Vienna, October 22, 2020

Scoping Statement

Environmental Impact Assessment (EIA), , on lifetime extension Loviisa 1&2

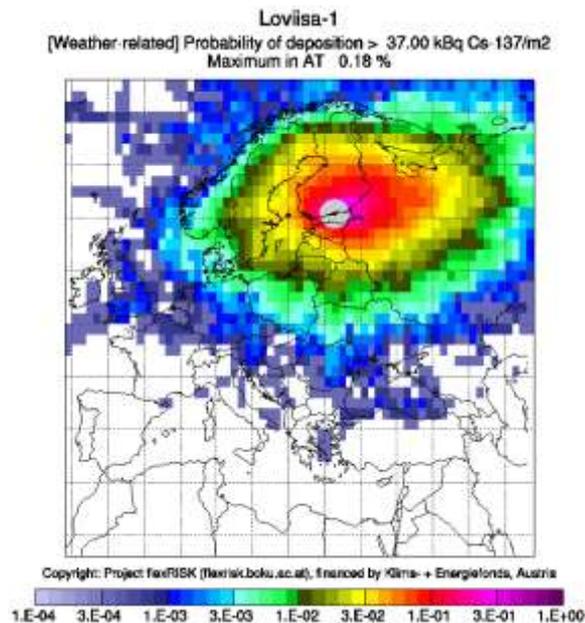
The research project flexRISK shows that a steam generator tube rupture accident in Loviisa unit 1 or 2 could release up to 30% of the radioactive inventory, that is 31.5 PetaBecquerel Cs-137.

The following flexRISK figure shows the weather-related risk for Europe to be contaminated with Cs-137 above 37 KiloBecquerel Cs-137 per m² in case of such an accident happening.

Under unfortunate weather conditions, almost every country in Europe could suffer such a high Caesium contamination.,

The EIA Report shall also include accident calculations with the highest source term for which the risk is not zero, and dispersion calculations for all of Europe.
